Serial No. 09/817,278 - Amendment Filed: March 27, 2001 - Attorney Docket No. 618-979

Amendment in response to Office Action dated 01/08/2002

For: MULTI-MODE LIGHTER Appendix C Page 1 of 3

Fig. 4

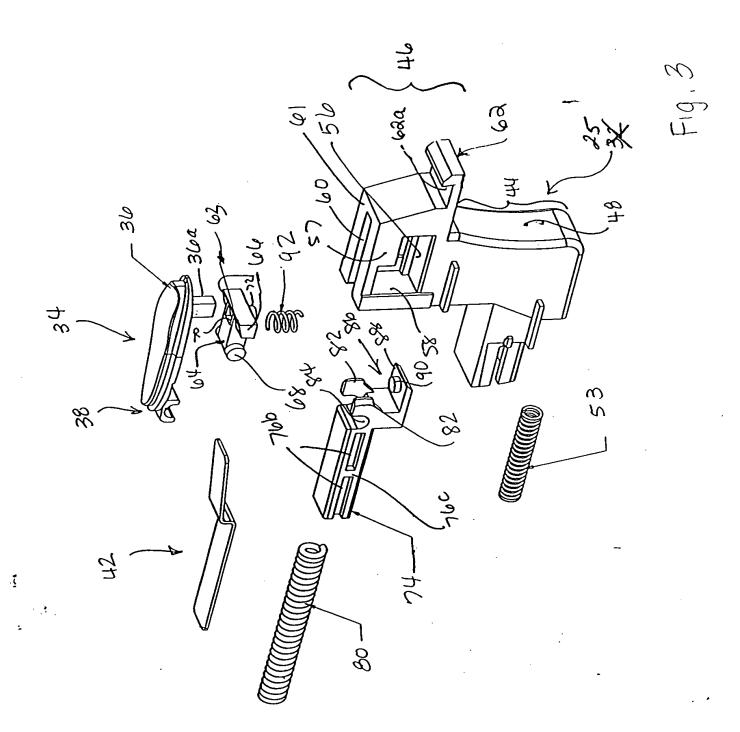
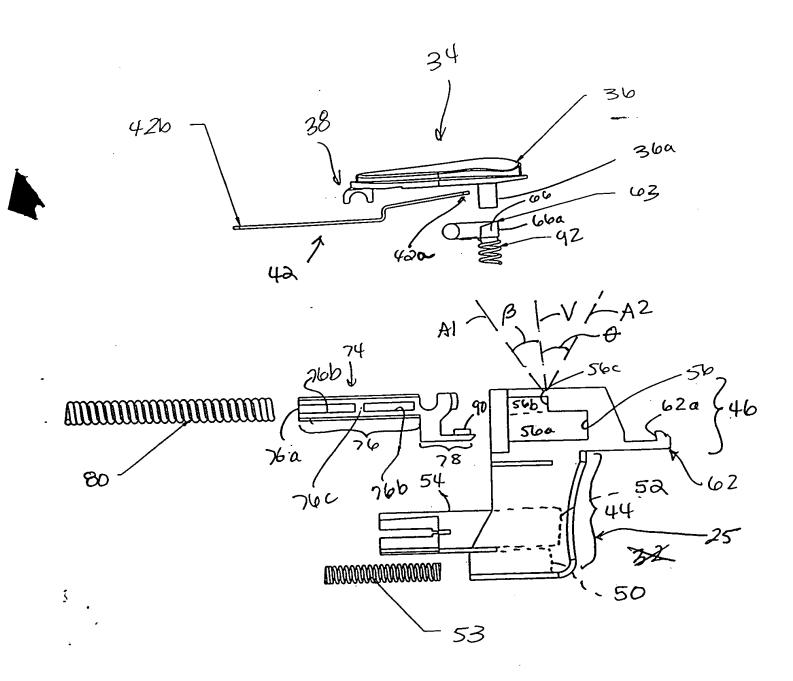
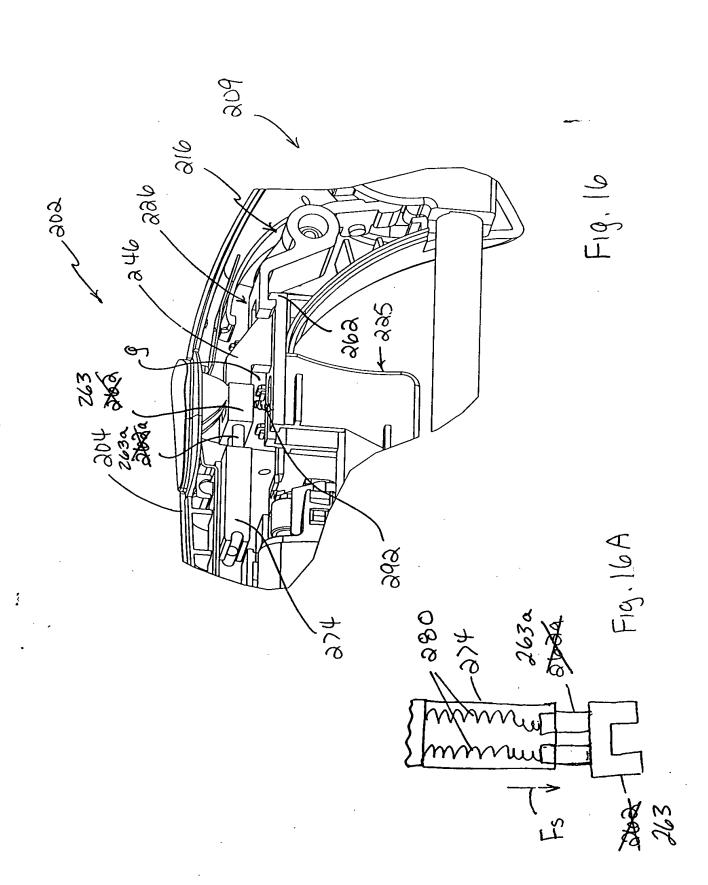
In the Office Action dated January 8, 2002, the Examiner objected to Fig. 3 and Fig. 4 because "it is unclear what reference number 32 represents." The Examiner noted that in other figures "the trigger is element 25 and the cam is element 32." In response, Fig. 3 and Fig. 4 have been amended as indicated in red on the copies of these figures attached as Appendix A to clarify that the trigger is element 25. Accordingly, Applicants respectfully request that the objection to Fig. 3 and Fig. 4 be withdrawn.
